**Project Name:** 701 SW 2<sup>nd</sup> Court (2018-037)

**Request:** Class II Site Plan Modification

# SITE PLAN REVIEW AND APPEARANCE BOARD STAFF REPORT

File No.: 2018-037-SPI-SPR-CL2

A-1

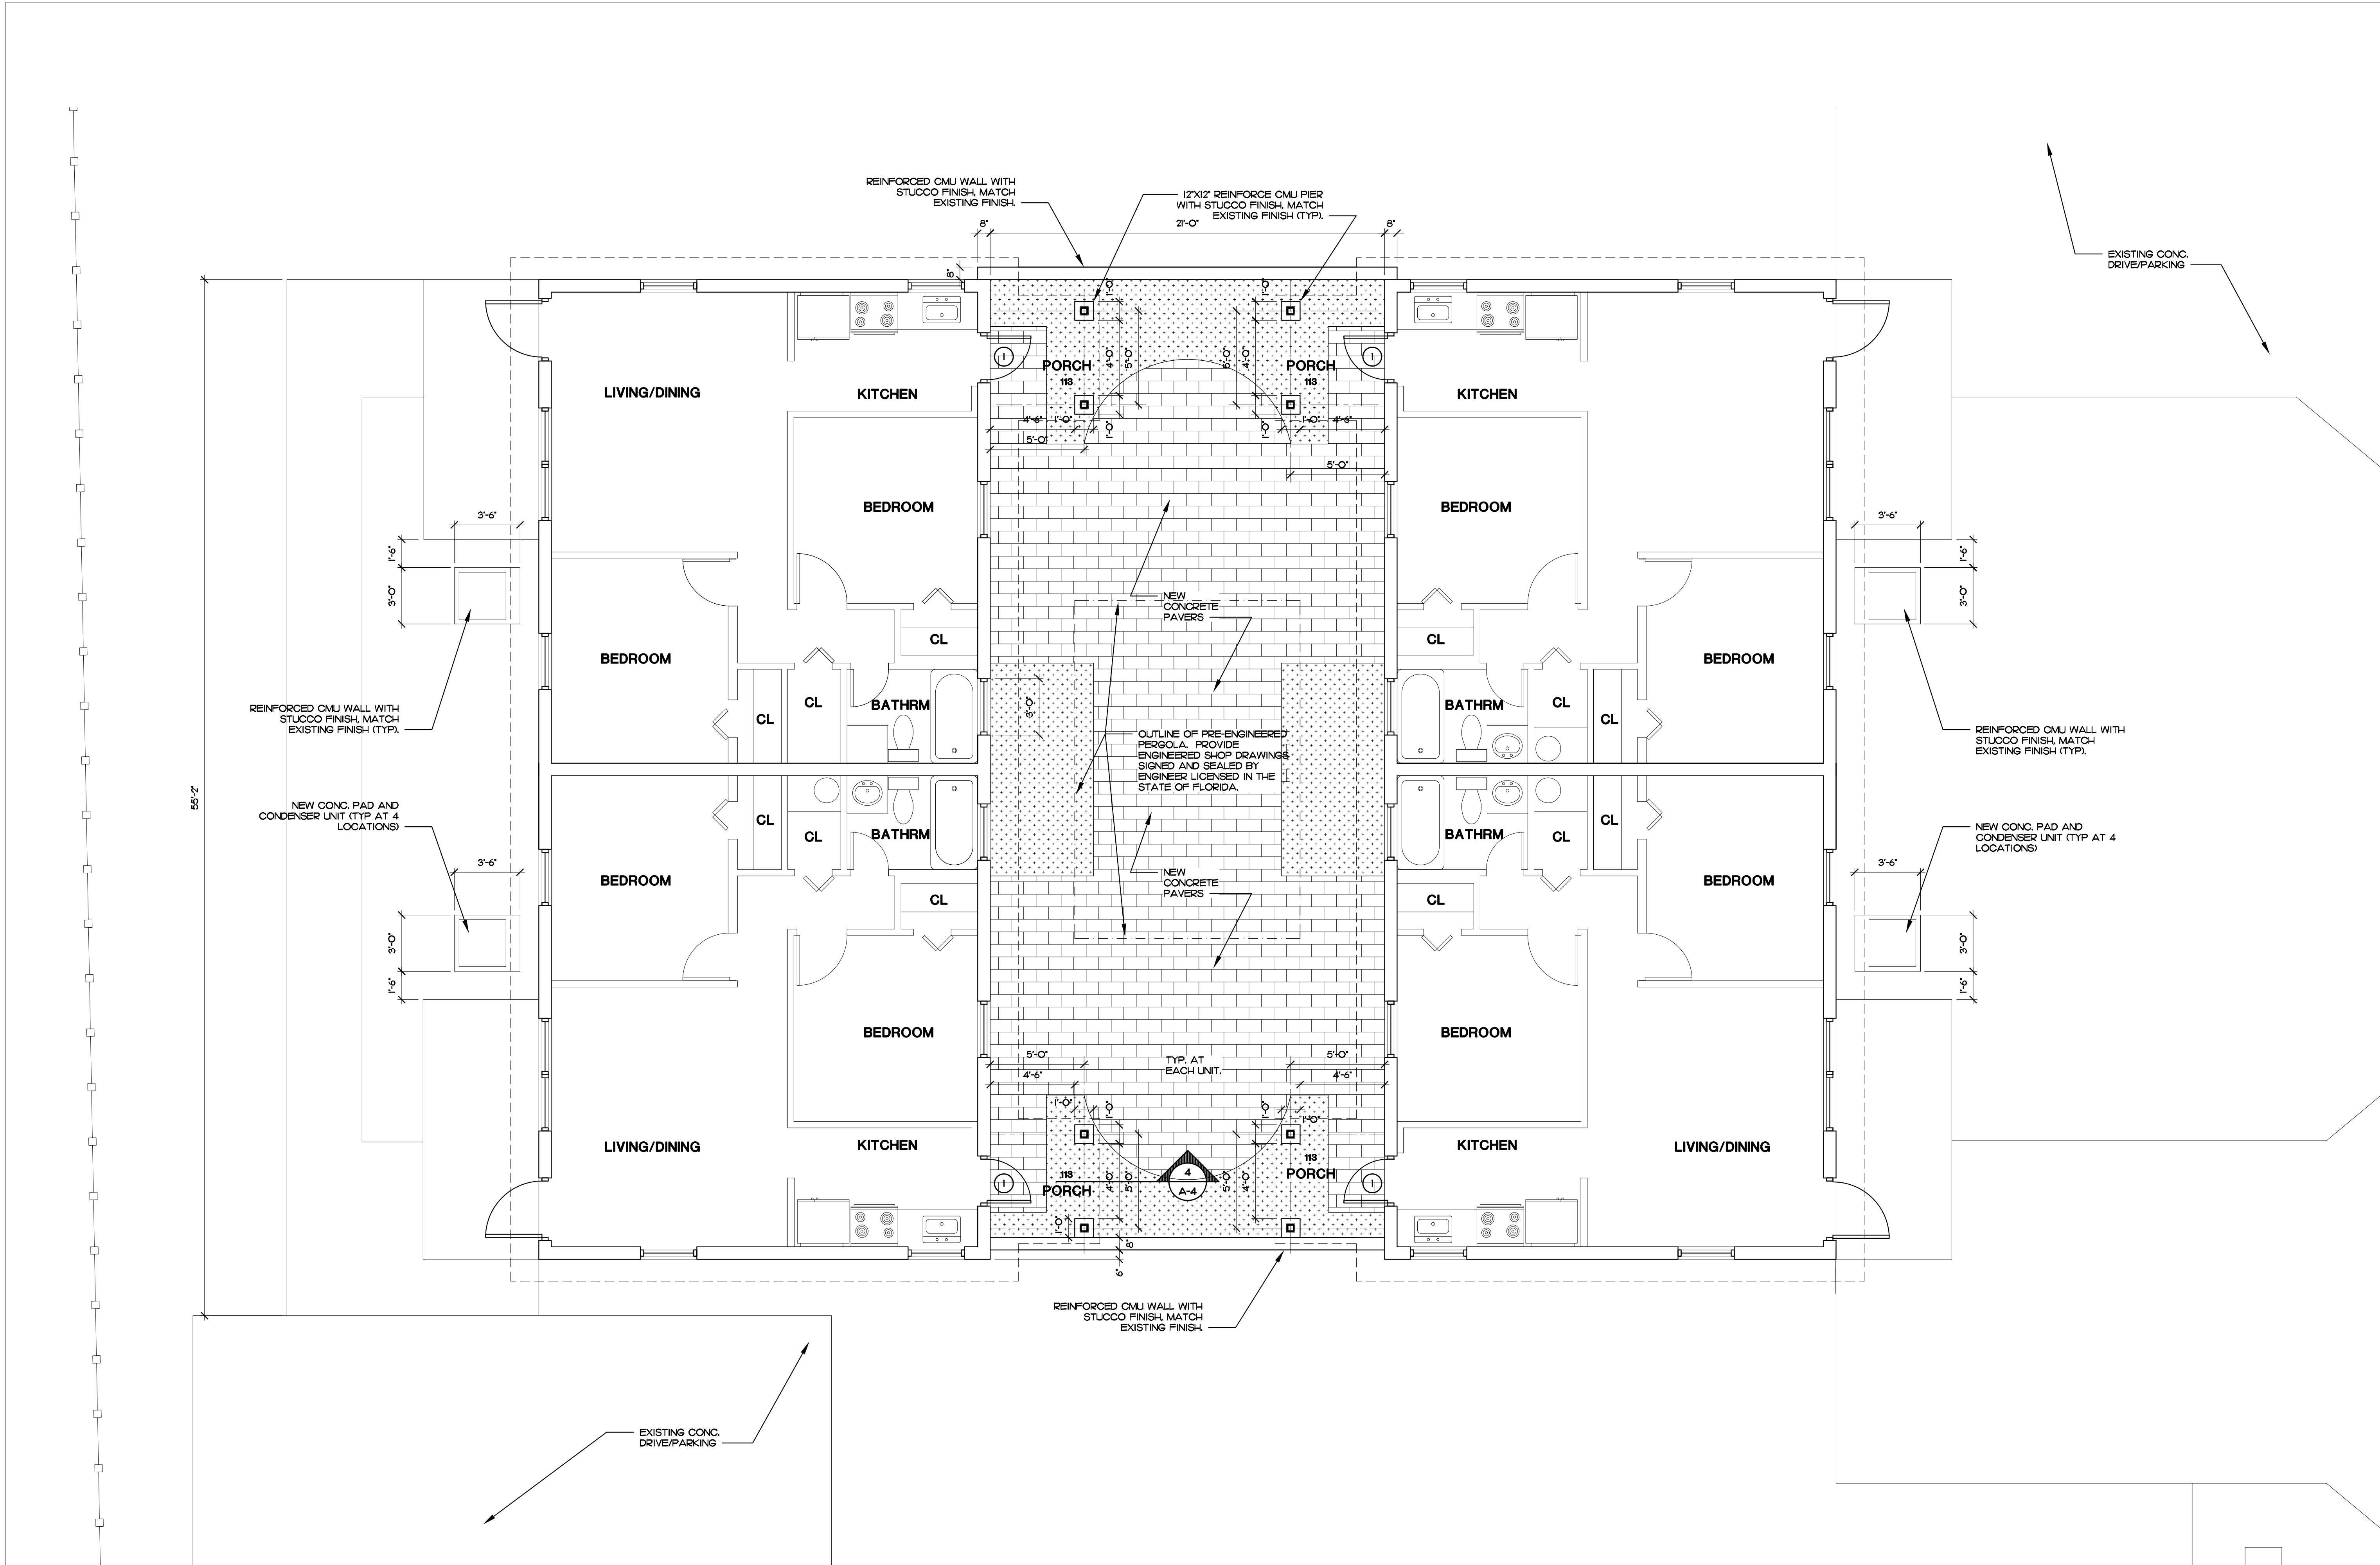
- ✓ The subject property is located in the R-1-A zoning district. Therefore, a minimum front setback of 25' along SW 7th Avenue, and a minimum side street setback of 15' along SW 2nd Court shall be provided. According to the survey provided, the existing front setback along SW 7th Avenue is 18.7' and the existing side street setback provided along SW 2nd Court is 24.9'. The front setback nonconformity shall not be altered or enlarged in any way which increases its nonconformity, per **LDR Section 1.3.4**. The proposal does not include any changes to the existing setbacks and it is not increasing an existing nonconformity, thus meeting the code requirements.

- ✓ Per provided Site Plan, the site area is 10,498 sq.ft.; the proposed pervious area is 4,825 sq.ft. which makes it 45.9% of total lot area, thus meeting the code requirement.

A-2

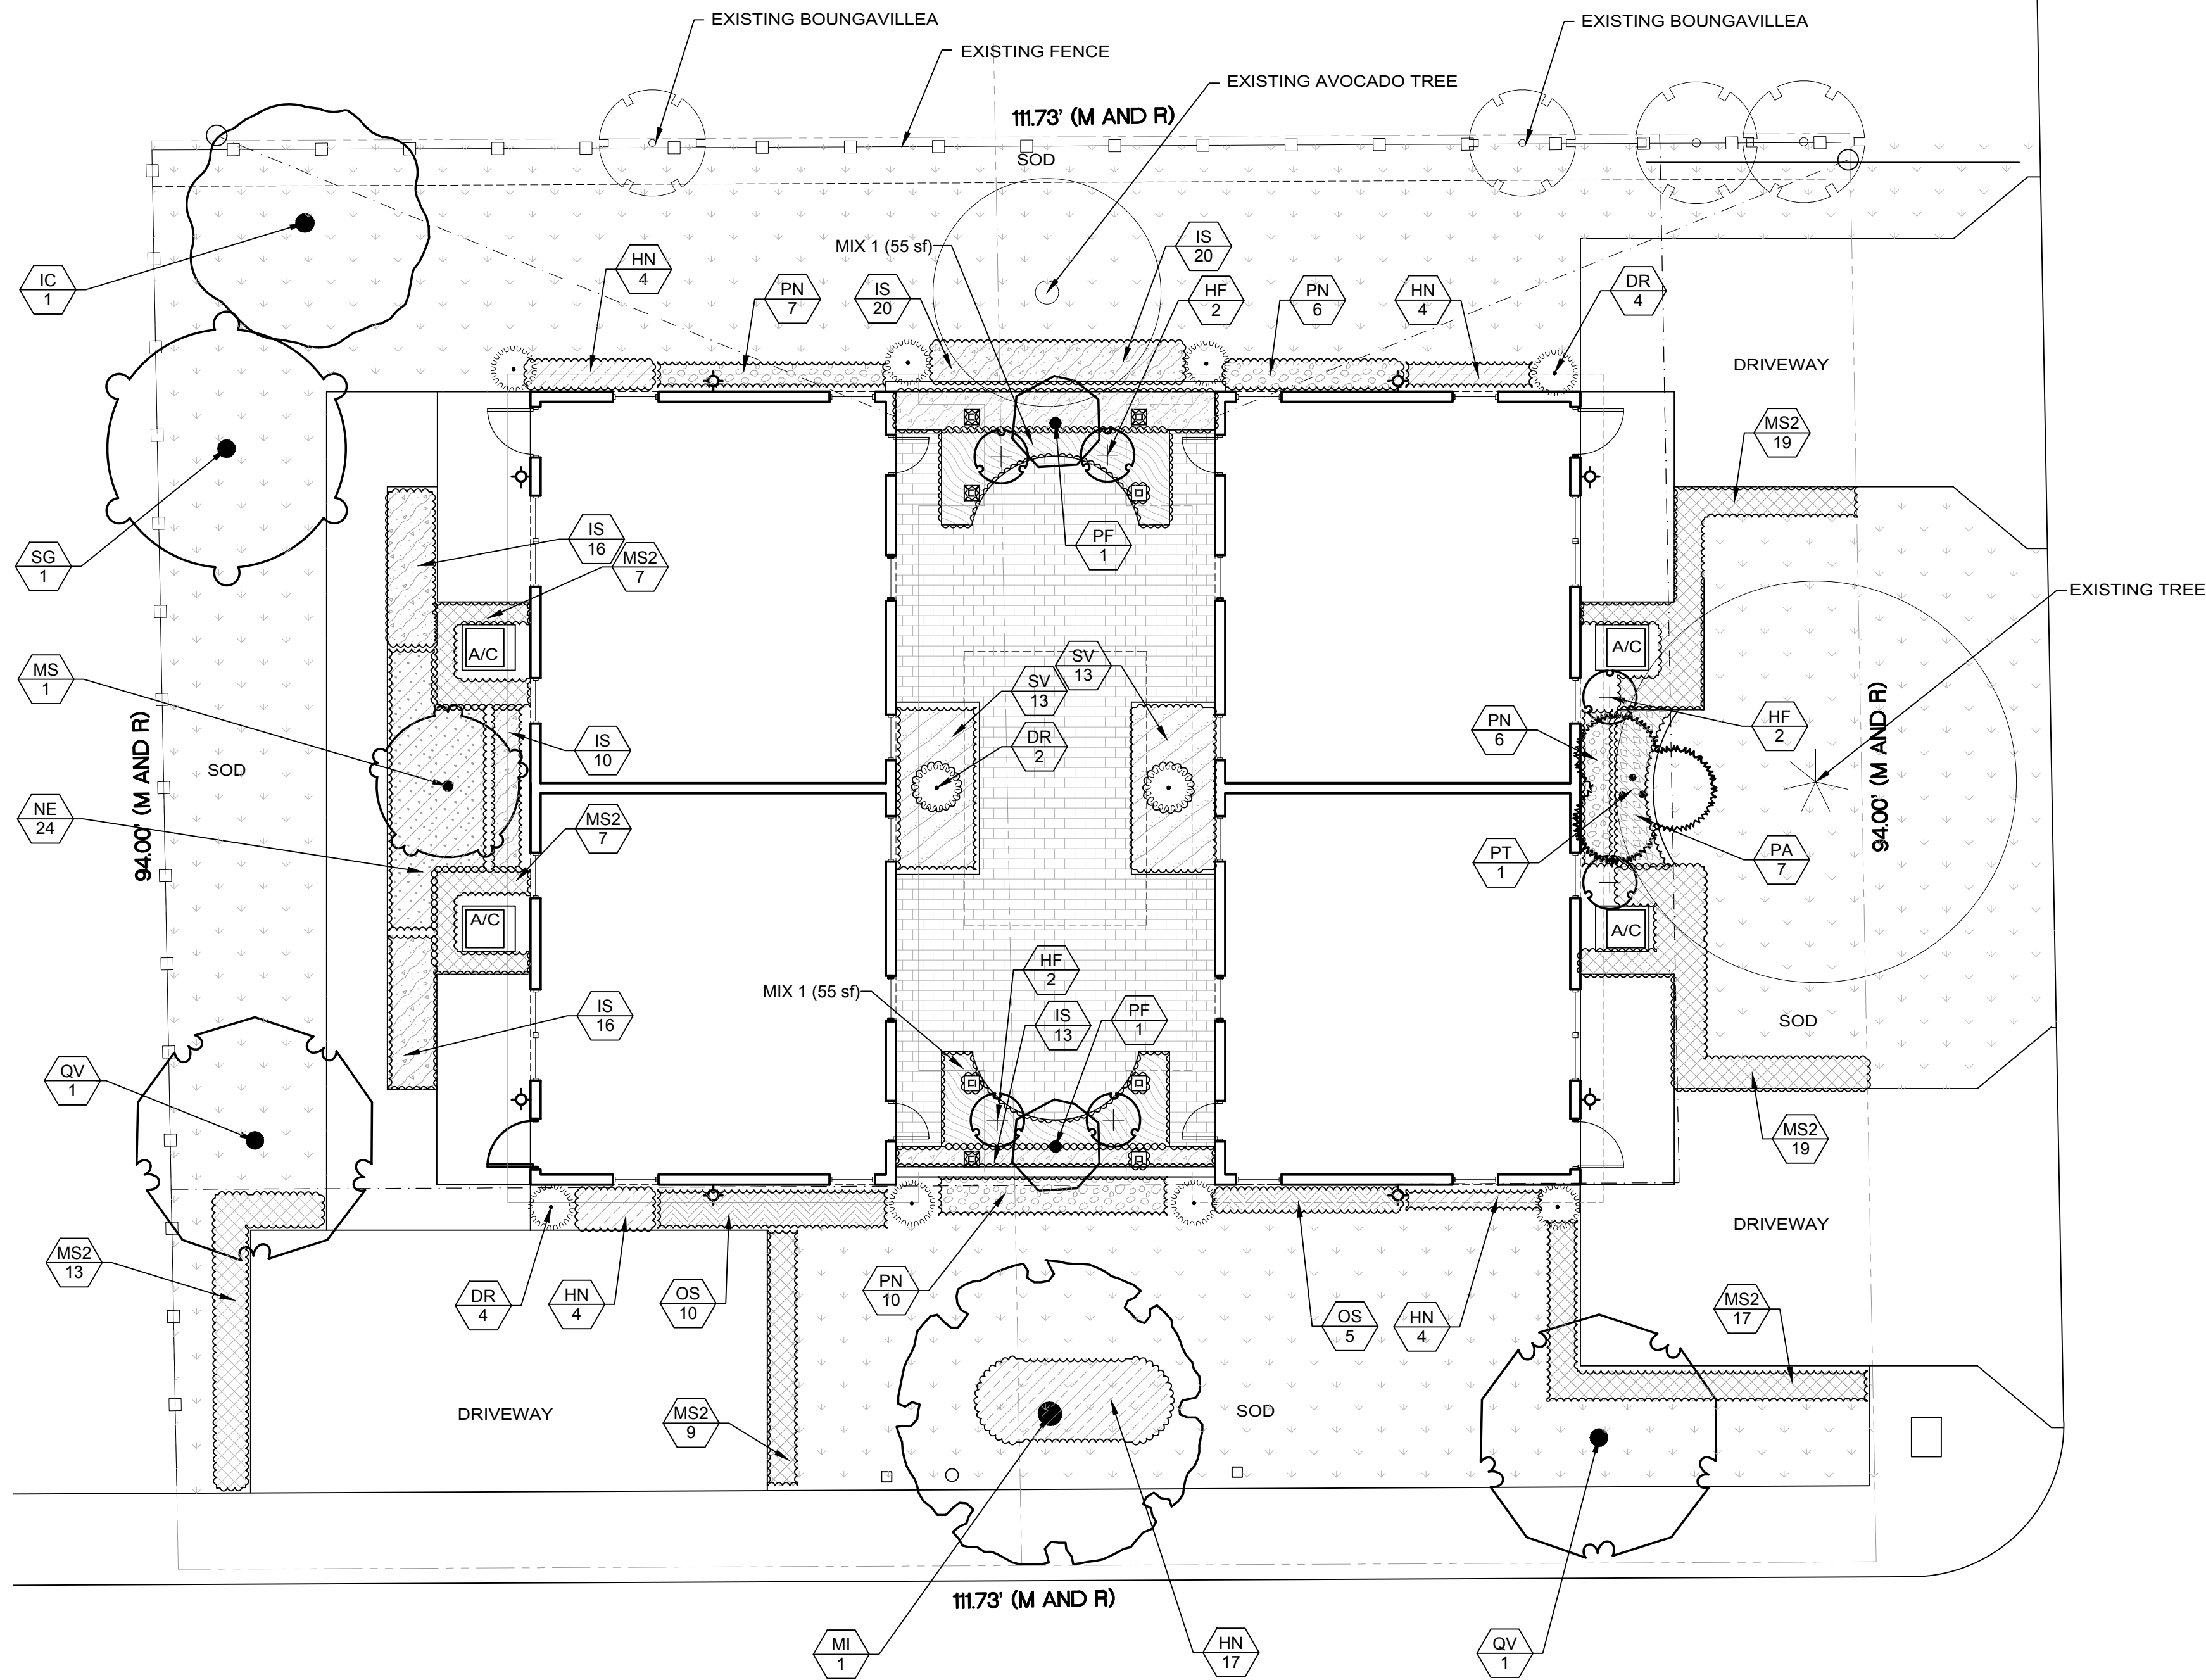
- ✓ The proposed architectural elevation changes include the construction of 4 new covered porches that are 5' long in front of the existing doors, replacement of 4 doors with new fiberglass doors with impact windows, installation of a new 4' tall wall on the north and the south side in between the buildings in order to enclose and create a courtyard between the duplexes, placement of pre-engineered pergola in the middle of the proposed courtyard, and change of color for the building's façade to SW 6750 Waterfall and the roof to Timberline Barkwood Shingles.

- ✓ No changes in the number of units or building height are proposed with this request. The proposed architectural elevation changes will not adversely affect the surrounding area, will not materially depreciate the neighboring areas, and the proposed changes are consistent with the selected architectural style Based on the above, positive findings can be made with respect to LDR Section 4.6.18(E).
